Date: 23 December 2025
Arcadis Ref: 30255527 (122047-prev.) – Task 0019
Subject: Devens Peer Review
CFS-3 – 125, 111 and 105 Hospital Road
Parcel ID 018.0-0007-0200.0

Arcadis has reviewed the comment responses and second drawings submittal for 125 Hospital Road – Level 2 Unified Permit Application Documents dated 11 December 2025, including the following supporting documents:

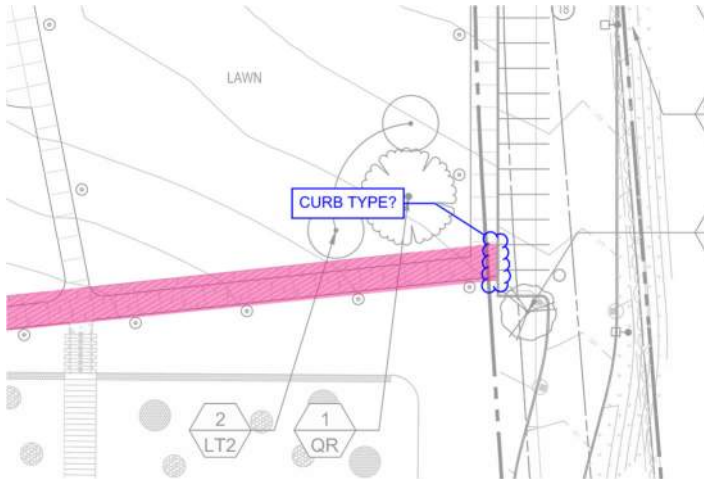
- a) Tree protection detail shows tree protection fence at tree dripline. Tree protection fencing is required to be 12" minimum beyond dripline of trees.

- a. The true extent of the R&D for the site landscape is not documented. Please provide additional notes, or graphic representation of the R&D. Include these trees and the tree protection symbol on **all** plans with the true canopy size and update the tree protection detail to extend a minimum of 12" beyond the dripline of trees. Provide a description of the excavation methods within rootzones of trees to remain.

- b. The tree protection lines are not accurate as shown on the plans, as certain construction activities cannot be accomplished without cutting through dripline/root zones of existing trees if show at true size in plan. Adjust the limit of tree protection line and identify means of tree protection to remain in place for the duration of the project on all plans.

- c. Existing tree sizes are not shown on the plans; identify all trees over 12" within 100' of the property line and indicate the true canopy size of all trees to remain, or as otherwise directed by DEC representative. Our understanding is the DEC has granted a waiver for the 100' dimension but requests all trees with driplines affected by the Limit of Work shall be documented on all plans. This shall include those inside and outside the Limit of Work.

- d. Provide a Limit of Work on all plans that accurately reflects the maximum limit of disturbance during construction that does not extend to within 12" of the dripline of any trees to be protected for the entire duration of the construction activities, including those within the right of way to be protected.

The tree protection detail has been revised to show the 12" minimum beyond the dripline of trees.

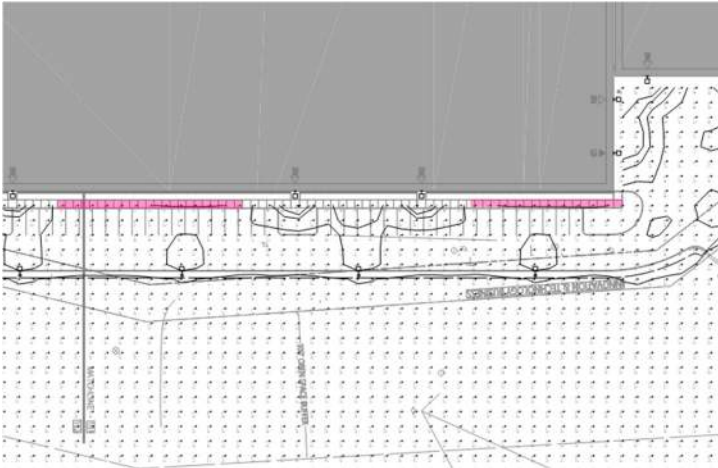
- b) Proposed and existing trees to remain shall be included on site lighting plans and photometrics to ensure no conflicts.

Comment is not addressed. The symbols are added, but do not factor into the lighting levels/contours. The photometric plans are the same as before the trees were added.

Concur, proposed and existing vegetation will be added to the plans.

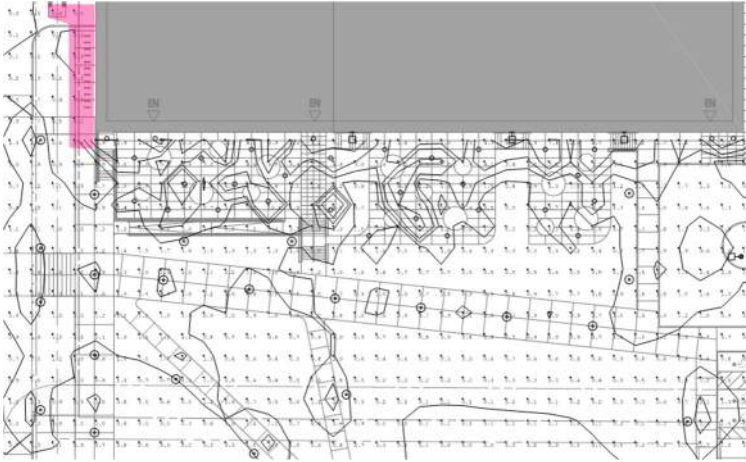
- b) Proposed and existing trees to remain shall be included on site lighting plans and photometrics to ensure no conflicts.

Comment is not addressed. The symbols are added, but do not factor into the lighting levels/contours. The photometric plans are the same as before the trees were added.

Concur, proposed and existing vegetation will be added to the plans.

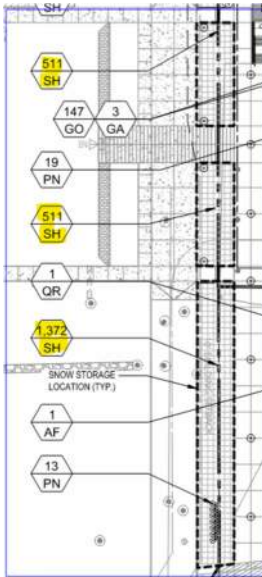
- a) The following plant material is identified as having low tolerance to road de-icing salts and has been placed within 20' of proposed roads/paved areas and should be substituted with tolerant plants and/or moved out of 20' buffer:

- i) *Ilex opaca*
- ii) *Rhododendron carolinianum*
- iii) *Sporobolus heterolepis*

Sporobolus monoculture remains and is specifically called out as snow storage areas which concentrates the de-icing chemicals. Revise and resubmit for review.

The identified plant material will either be substituted for salt tolerant material or shifted beyond the 20' offset from roadways.

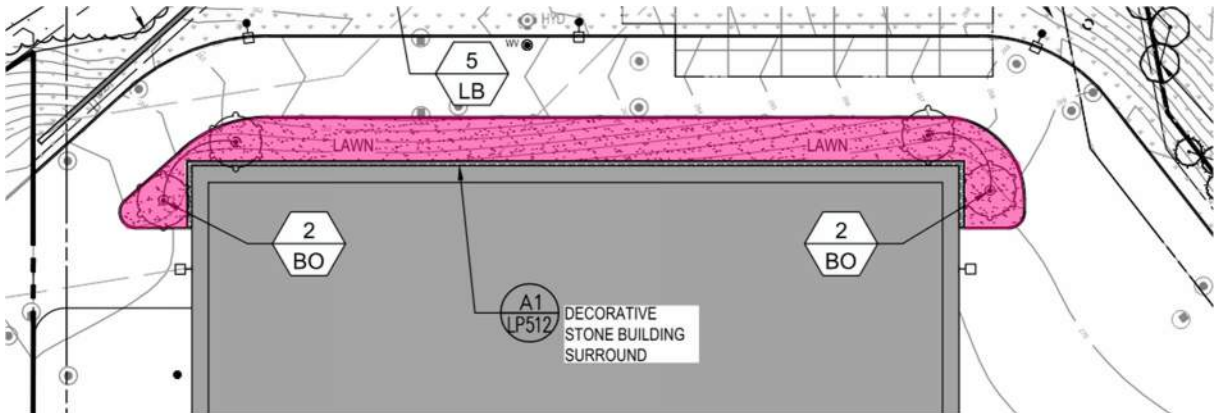
- a) Confirm that soil testing has been conducted and plant material has been selected based on the soil test results, specifically the New England Wetland Plants Wildflower Mix.

Topsoil test reports for the CFS site for the CFS-2 project have been provided to the CFS-3 design team. Soil tests were performed by UMass Amherst and dated May 2, 2025. The reports indicate test results along with recommendations for amendments. I reviewed the test results with New England Wetland Plants, and they indicated that the pH and organic matter content are acceptable. Further, NEWP indicated that too many additional inputs or amendments could potentially harm or burn the seed.

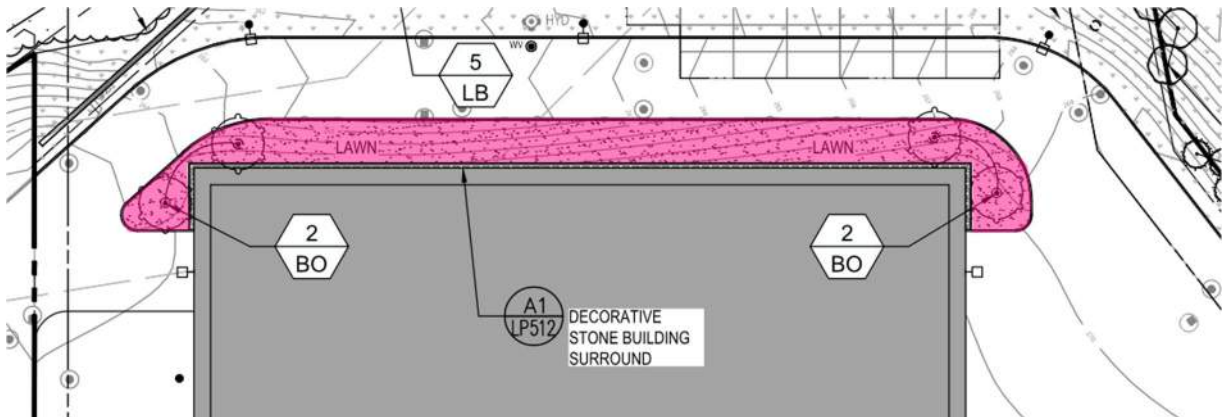
- b) Confirm that 50:50 New England Wetland Plants Wildflower Mix and Erosion Control Mix for dry sites proposed at all areas to be re-graded is appropriate for 1:2.5 slopes. Consider a 100% Erosion Control Mix on steep slopes at or over 1:3, and Meadow Mix in areas under 1:3.

We agree with 100% Erosion Control Mix on steep slopes at or over 1:3, and 100% Meadow Mix in areas under 1:30

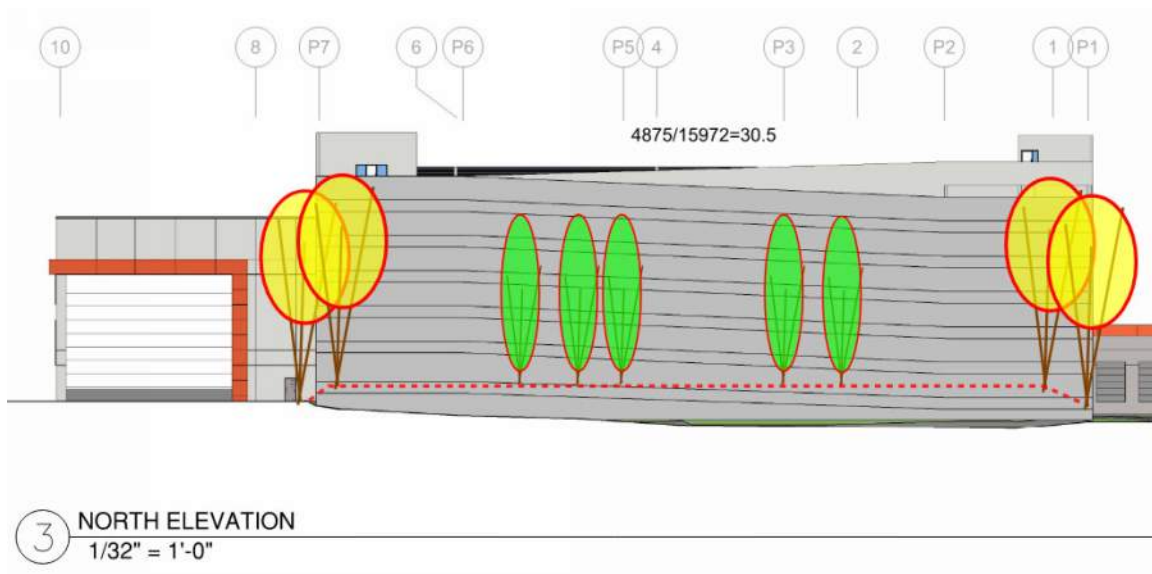
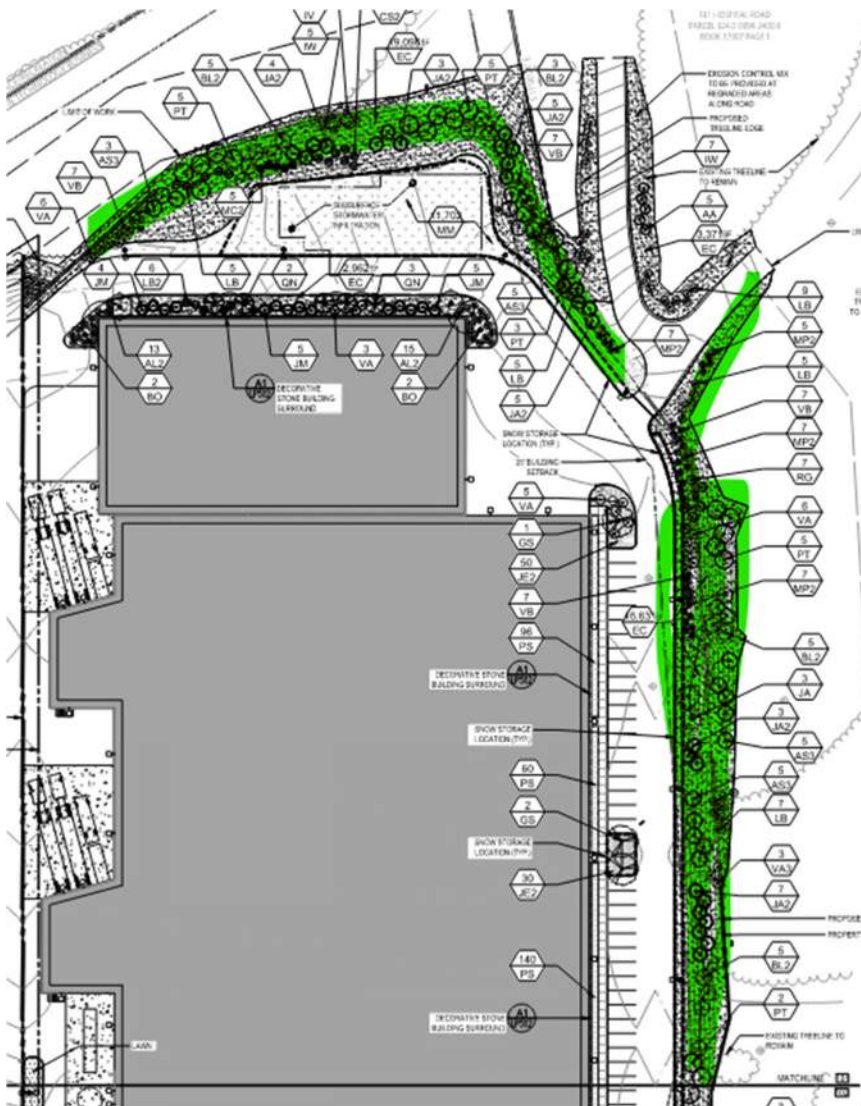
The *Betula* species selected seems too large for the location, likely growing into the garage and overhanging the truck route. The proposed evergreens are either underrepresented in plan scale, or too small to be effective as a screen. Suggest the applicant add the proposed buildings screening materials to the sheet PL-1 – PL-3 to effectively convey the screening solutions.

There seems to be an opportunity to increase the density of large evergreen planting on the north and east sides of the parking garage outside the vehicular circulation zones. As submitted, there is only one genus of evergreen in the plant schedule, *Juniperus*, both of which are varieties/cultivars. Our understanding is the DEC encourages planting of straight species to allow for the best chance of survival. Consider this for other plant selections as well. Indicating the trees in plan at 70-80% mature spread would also help to reinforce that the screening approach will be effective. Show mature height and spread in the plant schedule for all selections.

The need for additional screening in this area is reinforced by the proposed lighting levels within the garage. Though lower than the first iteration, the lighting levels within the garage still far exceed those required by DEC. Even if the levels are reduced further, it will be important to screen the light pollution from surrounding residential areas.

Per comment #6, and per item (5a), the highlighted area will be planted with deciduous and evergreen trees to help screen the garage. The understory layer will be planted with groundcover and native shrubs to stabilize the slope.

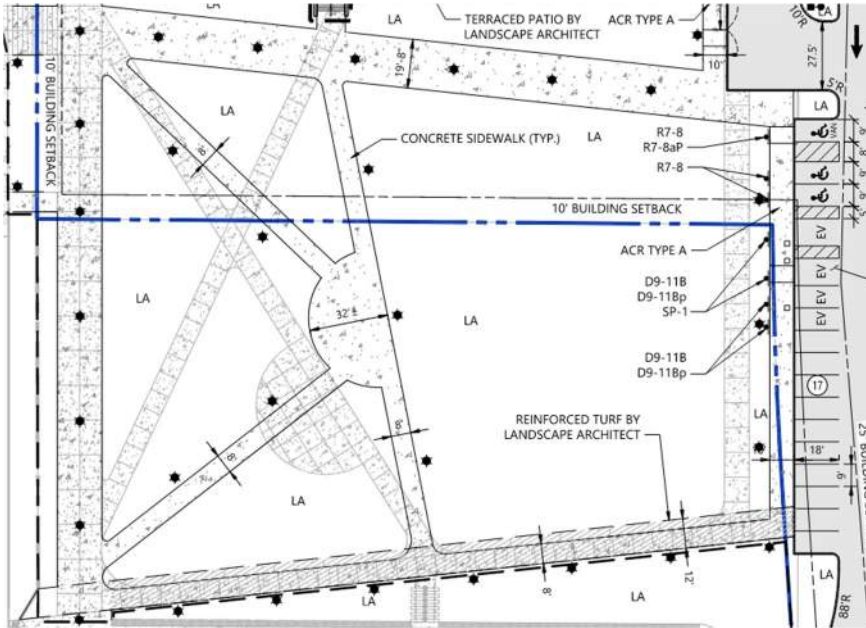
c) Please label limit of work line, setback lines, property lines on all plans.

Non-concur; Limit Of Work is not provided on the landscape plans.

Concur, will be provided.

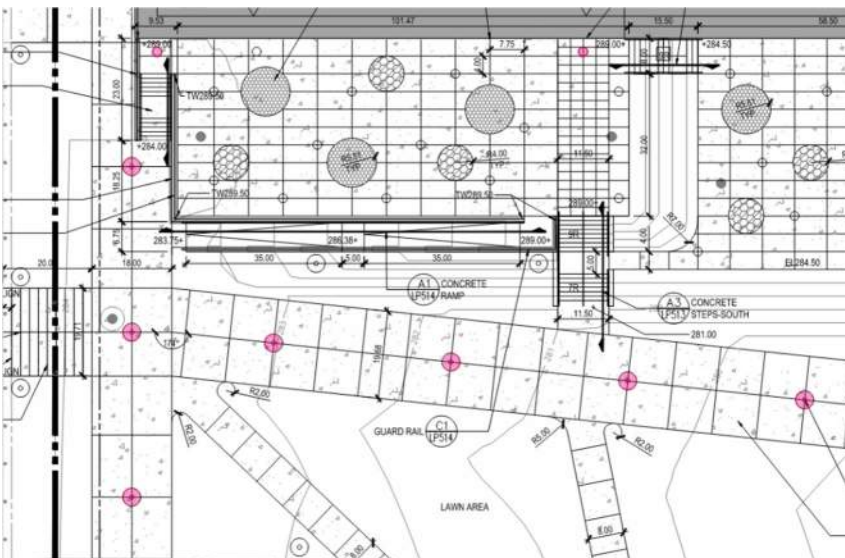
- d) Some plans currently show proposed quad walkways and screened back walkways, but it is unclear which is correct. Please differentiate between/label the two walkway layouts shown.

The screened back sidewalk in the campus green was part of a previously permitted design and was included to illustrate the changes proposed by this project. However, we understand that this has caused confusion and will remove the unnecessary linework from the plans.

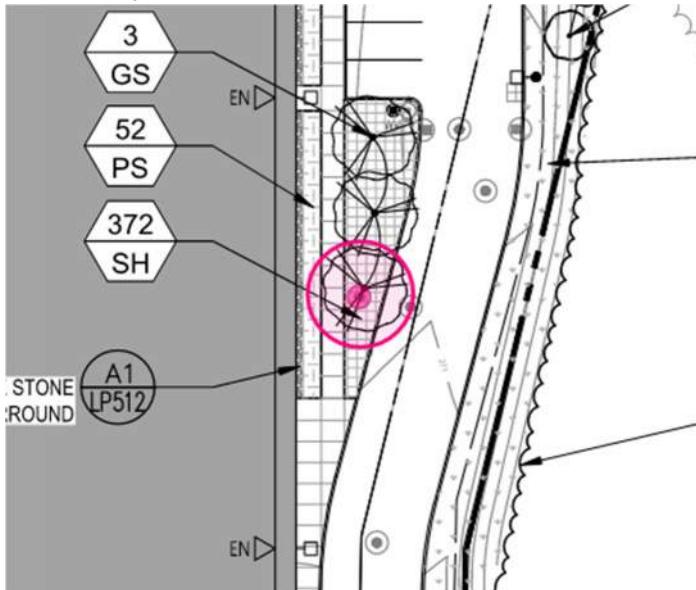
- e) At terrace and quad south of proposed building, light poles are proposed in the middle of walkways. This layout is not feasible from a maintenance perspective, especially snow plowing. Consider shifting light poles off walkways and off center of path of travel for consistency and ease of maintenance.

The centered lights within the pavement are part of a concept previously approved by CFS to create promenades connecting the campus buildings. These paths are 20 feet wide which offer ample space for snow maintenance on either side of the poles. The concrete bases extend above the paved surface and will help to protect the poles from damage.
